FORM-BASED CODE COMMITTEE

November 14, 2024

Case # FBC-24-4

1846 Market St.

Pedestrian Entrance not facing Primary Street

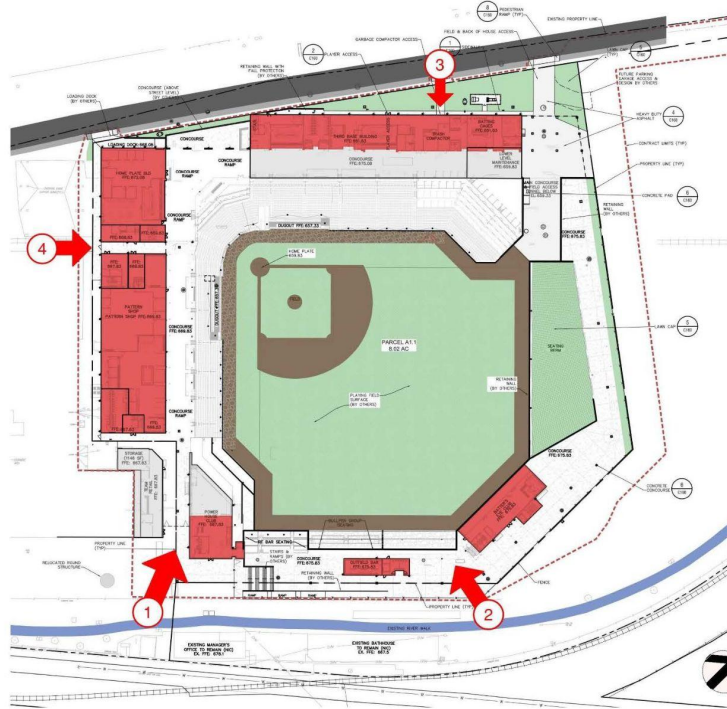
The project provides an entrance from the public realm (labeled as 3 and 4). However, this entrance is only available to staff and players.

The master developer focused on utilizing the Riverwalk as the “front door” (labeled as 1 and 2) to the stadium which allows the general public to utilize multiple transit options to access the Stadium while providing connectivity to many surrounding neighborhoods.

Garage Door to be seen from the Public Realm.

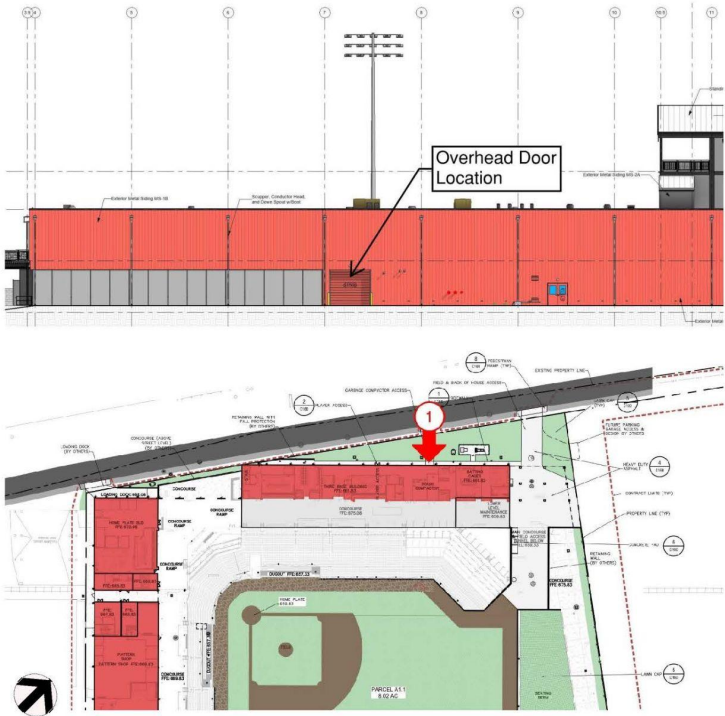
The Stadium will house a single dumpster / compactor located on the first floor. It has been located to allow all concourse and suite trash to be disposed through a shoot directly to the dumpster. With limited site circulation and road exposure the West façade was the most functional location.

To accommodate the dumpster there will be an overhead coiling door (12'-0" Wide, 11'-4" High) on the West Facing façade of the Ballpark (1 on the plan). The exterior wall containing the door is finished with a flush metal panel. The metal panels of the wall and overhead coiling door will be the same finish and color to maintain an attractive urban environment along the street.

Chain Link Material Incorporated into Building Façade.

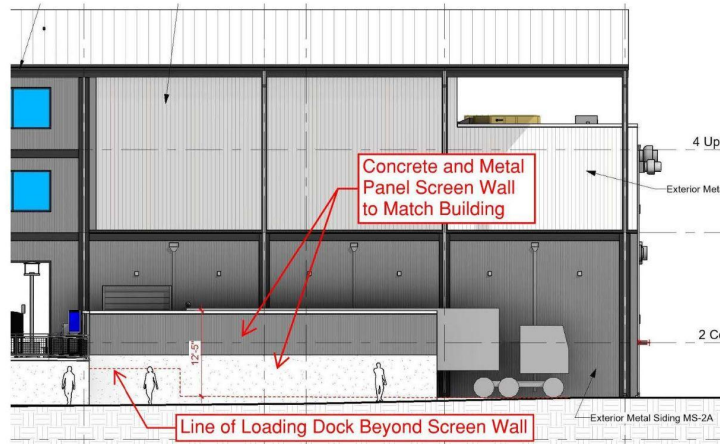
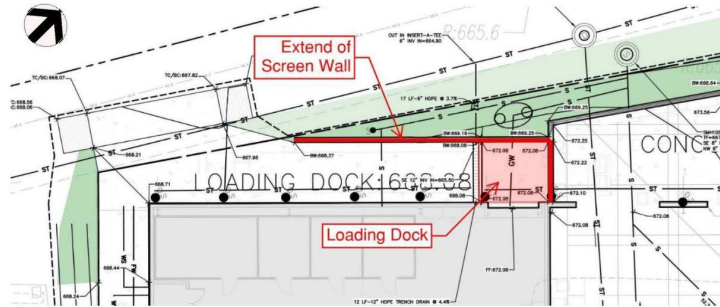
The first floor of the West Building will house the stadium's Hitting Bay. This space is required by MLB to be at the same level as the locker rooms and the field, and should be a covered exterior environment for the players.

Since the field is recessed, most of the first floor is below grade with the exception of West face of the building facing the Loop Road. To enclose the Hitting Bay there will be vinyl-coated chain link material incorporated into the building façade on the first floor level. For safety it is required to enclose the space with fencing to protect from stray balls, while maintaining the same outdoor environment.

This will not be a free standing fence but constructed as part of the building envelope. The vinyl-coated chain link wall will be 11'-4" tall and 90'-0" long.
